BEFORE THE MERIDIAN CITY COUNCIL

CASE NO. FP-2022-0010

ORDER OF CONDITIONAL
APPROVAL OF FINAL PLAT

SUBJECT: FP-2022-0010
Woodcrest Townhomes – FP, ALT

B. Final Plat (date: 2/7/2022)

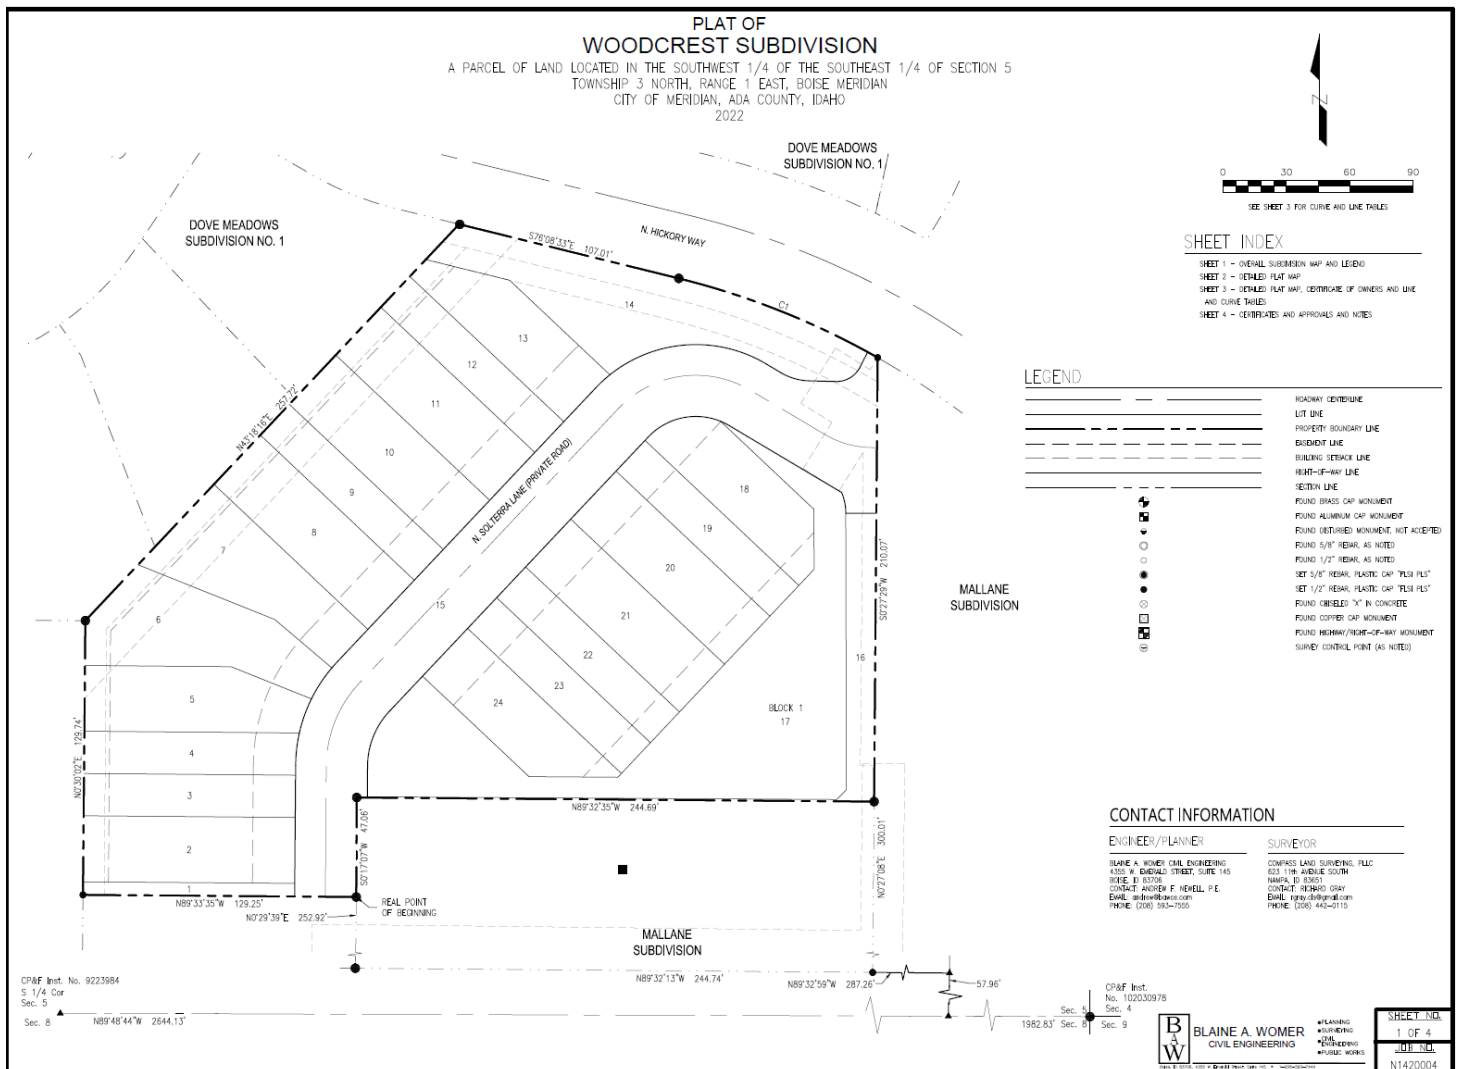
3. Prior to submittal for the City Engineer's signature, have the Certificate of Owners and the accompanying acknowledgement signed and notarized.
4. The final plat shown in Section V.B prepared by Blaine A. Womer Civil Engineering, shall be revised as follows:

- a. Note #10: "Lots shall not be reduced in size without prior approval from the health authority and the City of Meridian."
 - b. Note #14: Include the recorded instrument number of the ACHD landscape license agreement.

- c. Note #15: Include the recorded instrument number of the NMID license agreement.
 - d. Remove the former 25' landscape easement along the project's northwest boundary as it's no longer required with residential development.

- e. Remove the building setback line from the face of the plat and the Legend.
 - f. The final plat shall be stamped, signed and dated by the PLS.

C. Landscape Plan (date: 11/4/2021) & Amenity Detail

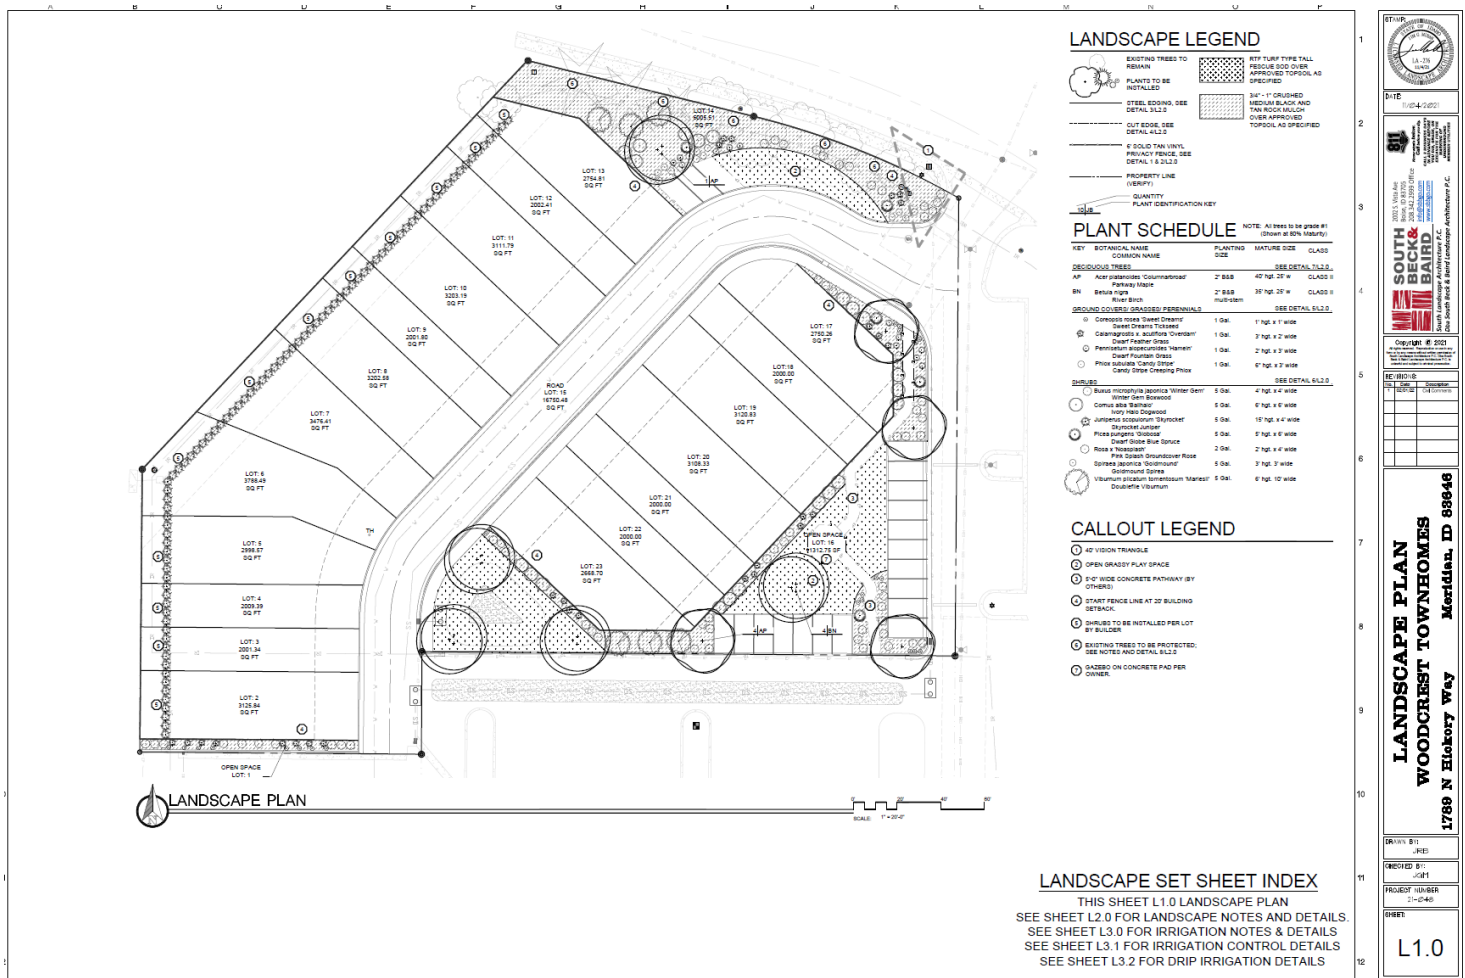
5. The landscape plan shown in Section V.C, dated 11/4/21, shall be revised as follows:
 - a. Depict a pathway from the sidewalk along the private street on the west end of the site through the common area to the parking area at the southeast corner of the site as required by preliminary plat condition #3a. Also, depict landscaping along the pathway in accord with the standards listed in UDC [11-3B-12C](#).

- b. Depict the location of the faux gate at the entrance to the subdivision off the north/south shared drive aisle from N. Hickory Way.
 - c. Remove the shrubs that are depicted along the northwest boundary of the site as a landscape buffer is not required with this development.

- d. The location of the pedestrian pathway on Lot 17, Block 1 shall be shifted away from Lots 18 and 19 as much as possible to comply with the standard in UDC 11-3B-12C.1, which requires a minimum 5-foot wide landscape strip to be provided along each side of pathways, while not encroaching in the 2-foot wide vehicle overhang area adjacent to the row of parking along the east boundary of the site.
